SUBJECT: Limerick Generating Station, Units 1 and 2
Application for Approval of Proposed Disposal Procedures
Request for Additional Information

LIMERICK GENERATING STATION
UNIT 1 AND UNIT 2

REQUEST FOR ADDITIONAL INFORMATION

Figure A.1

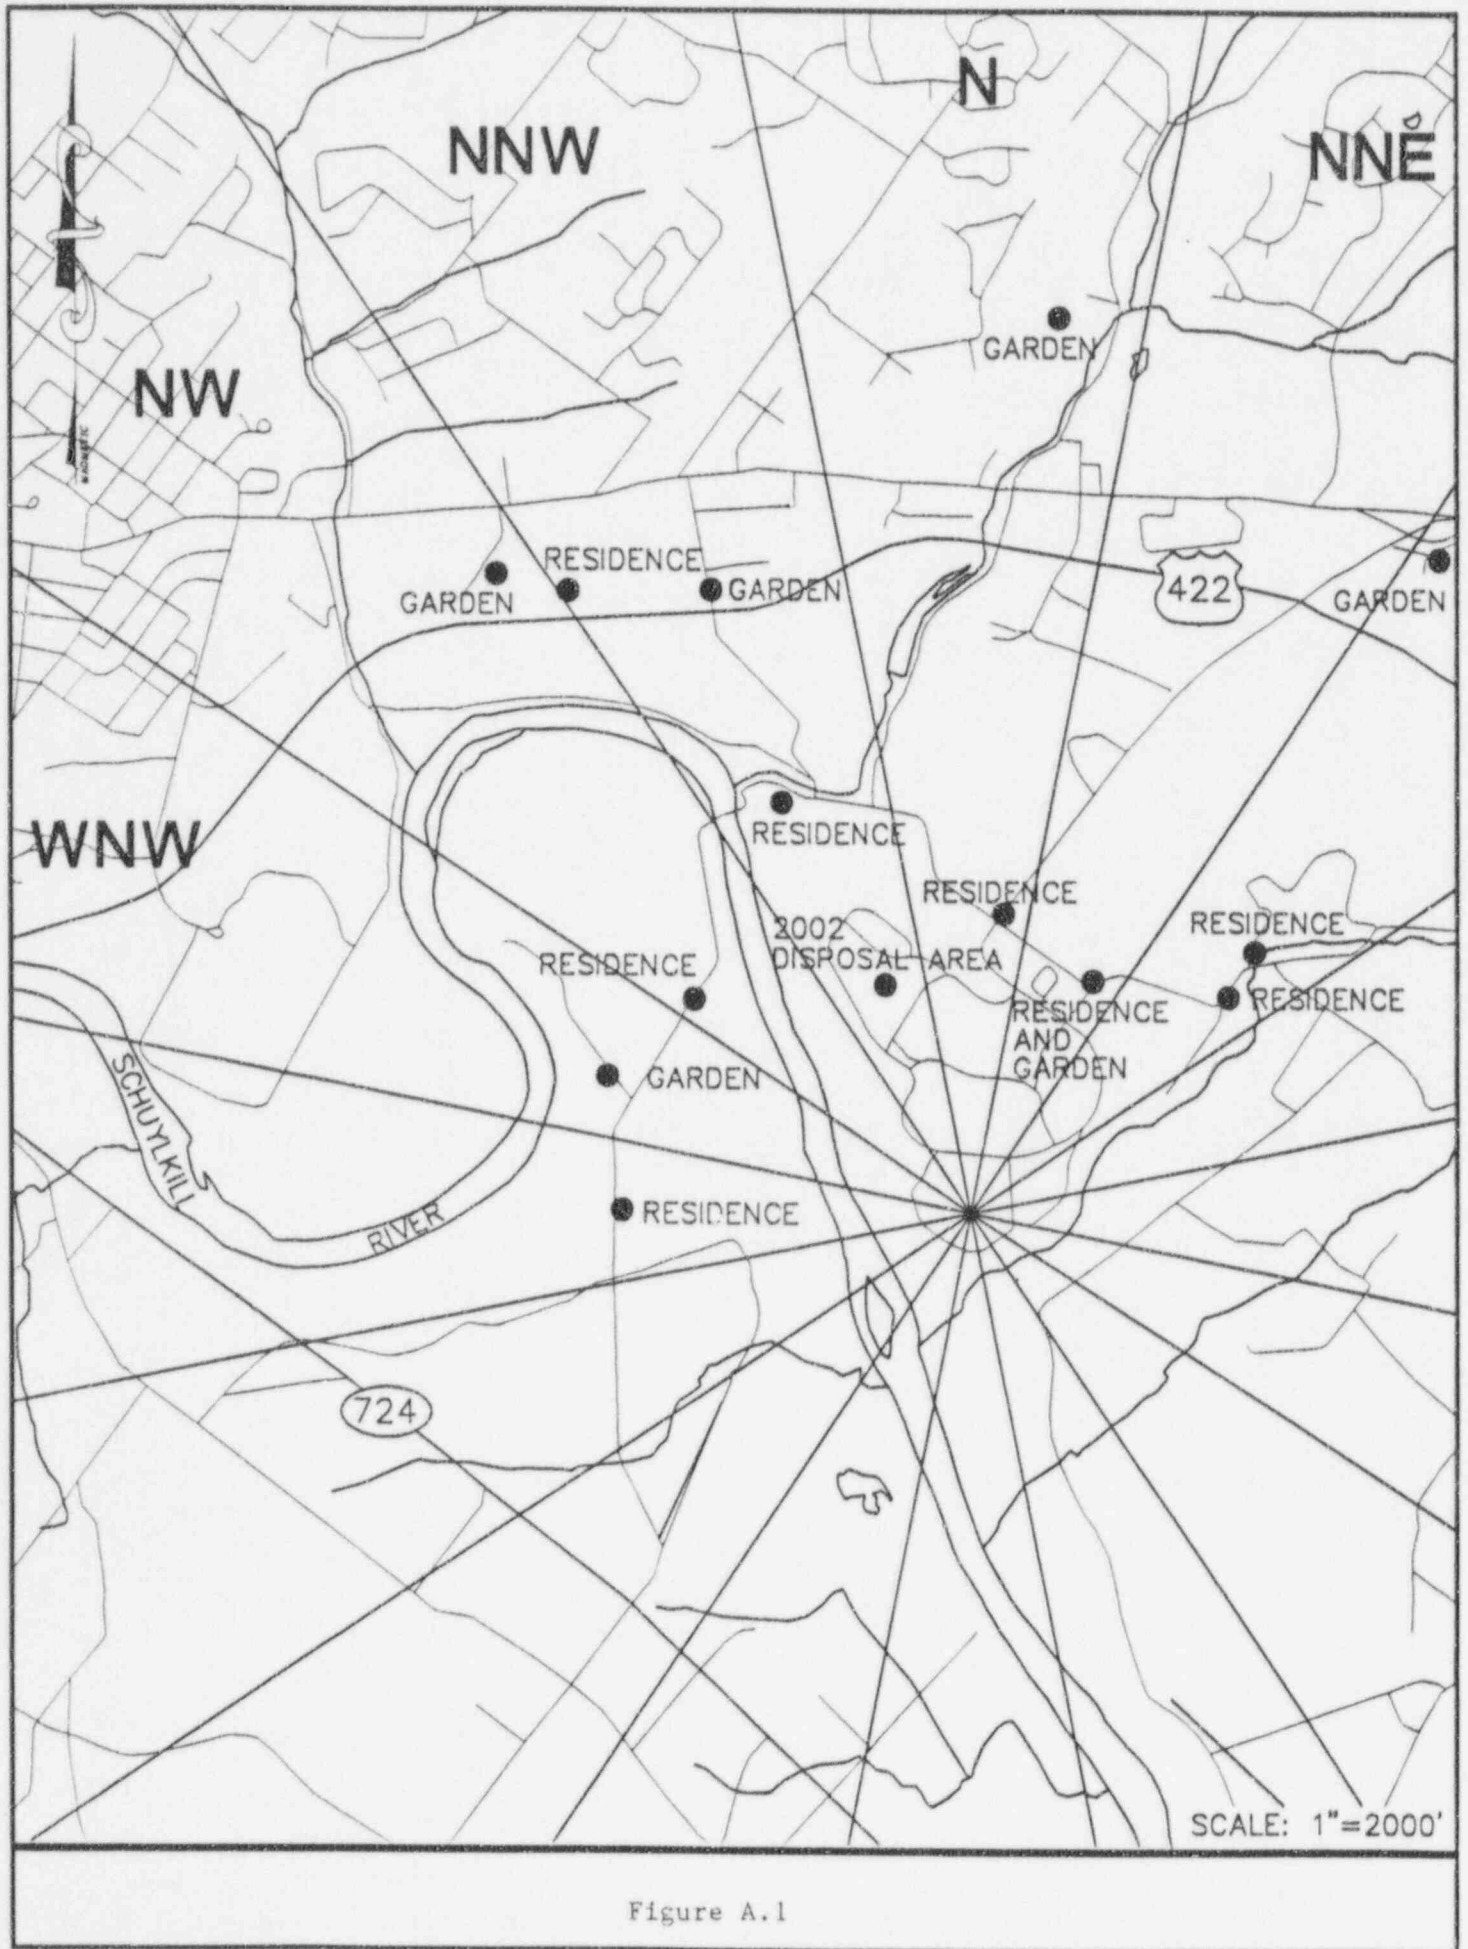
- 1.a What is the designated disposal site? Provide a legible map of the disposal site with compass direction and scale, that includes local land use (e.g., buildings, nearby residences, wells, etc.)
- 1.b Provide a pathway analysis from point of origin to final destination of the disposed contaminated material (see Figure 5.4, "Potentially meaningful exposure pathways to individuals," FES, 1984)
- 1.c In the application the licensee stated that the disposal volume will not exceed a total of 1,120,000 cubic feet. Please specify how the volume originated and how it will accumulate to this maximum volume. What is the yearly projected volume of contaminated waste?

- 1.a Figure A.1 of this Attachment provides the requested information. The nearest residence and garden are depicted in the W, WNW, NW, NNW, N, NNE, and NE sectors. The nearest well is assumed to be located at the nearest residence. Ground water movement is to the SW away from the nearest residence and towards the river. Figure A.2 shows a potentiometer contour map for the Limerick Generating Station Site depicting ground water movement.
- 1.b Figure B of this Attachment provides the requested information. The pathway analysis doses are based on the assumptions that the maximum amount of material (1,120,000 cubic feet) at the maximum concentration (specified in the 10 CFR 20.2002 application for all radioactive nuclides routinely searched for by the LGS effluent program) is placed in the designated area.
